Notice of Allowability	Application No.	Applicant(s)	
	10/631,945	LAWLESS ET AL.	
	Examiner	Art Unit	
	Douglas A Hess	3651	<i>NW</i>

EXAMINER'S AMENDMENT

Title: Conveyor System Load Transfer Devices
Serial No: 10/631,945
First Named Inventor: Robert Joseph LAWLESS
Docket No: 51595/276948A

FIG. 1

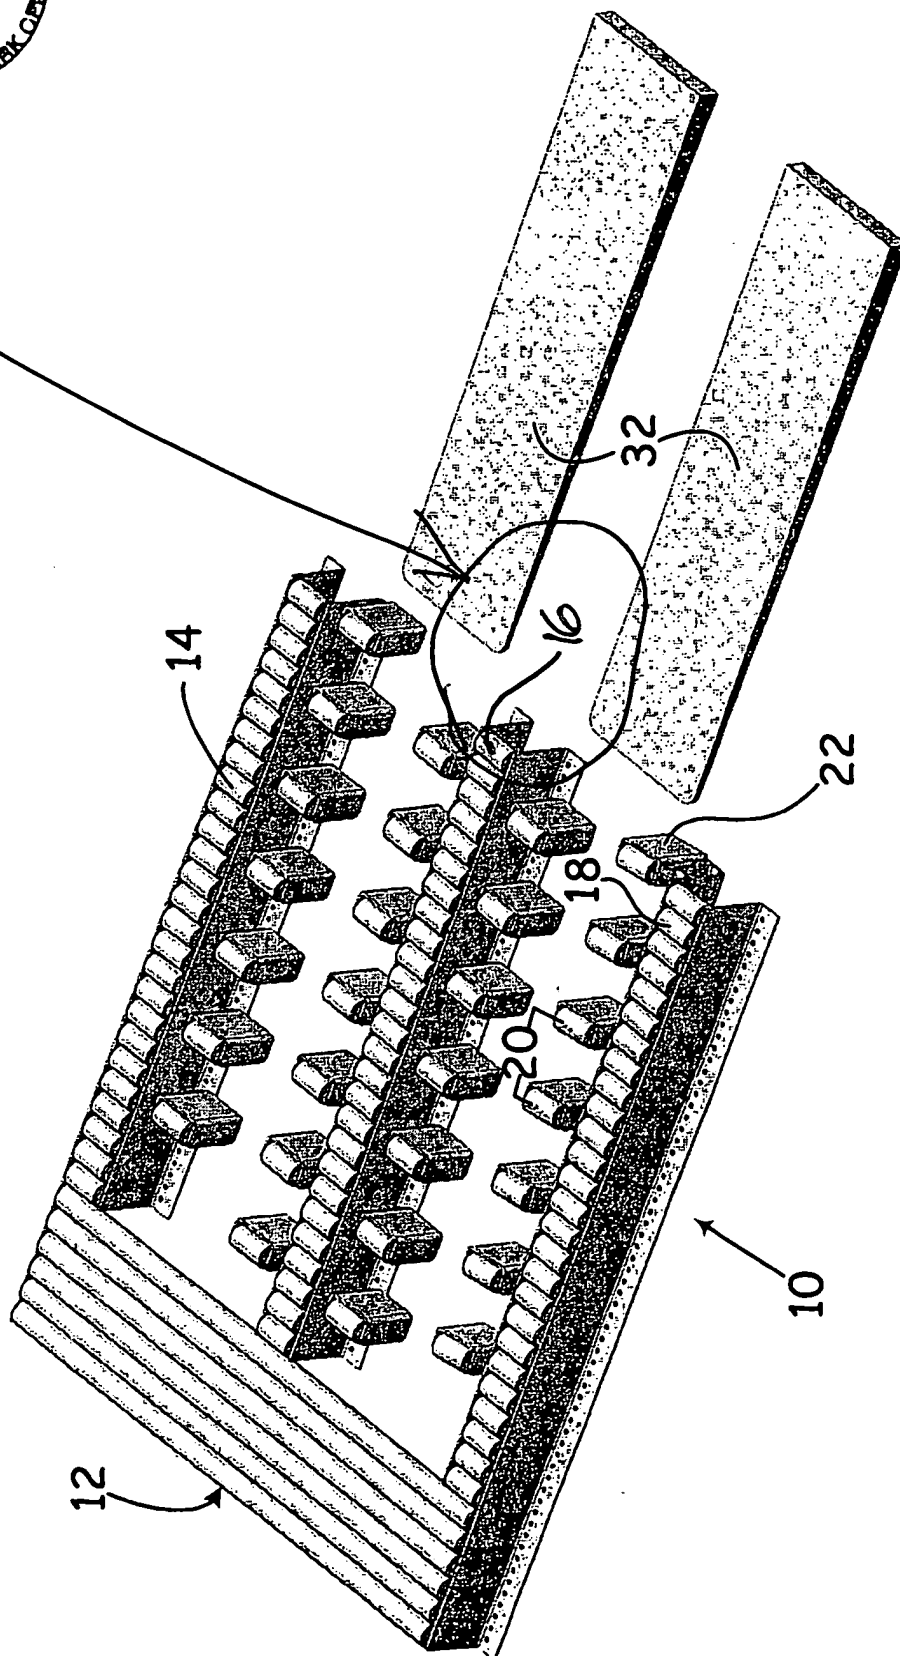
3. The following changes to the drawings have been approved by the examiner and agreed upon by applicant: In drawing figure 1, reference numeral --16-- has been inserted as shown on the attached marked up copy of figure 1. In order to avoid abandonment of the application, applicant must make these above agreed upon drawing changes.

added
16
